# Access Compliance Report

## Public Rights-of-Way

### (Pedestrian Signals)

Intersection ID: N/A	Main Street:	Cross Street: N/A	Location: N/A
ADA ID: B1B6745AEB22	Signal Type: One Push Button-Non APS	Overall Compliance: No	Severity Score: BTN 1: N/A BTN 2: N/A No BTN: N/A
Codes/Mitigation Info/Possible Solution		Field Measurements/Component Compliance

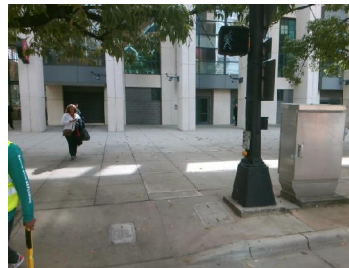
Possible Solutions: Provide Push Button Extension. Remove and Replace Clear Space.

PROW/ADA: R404.2, R404.3, R406.2
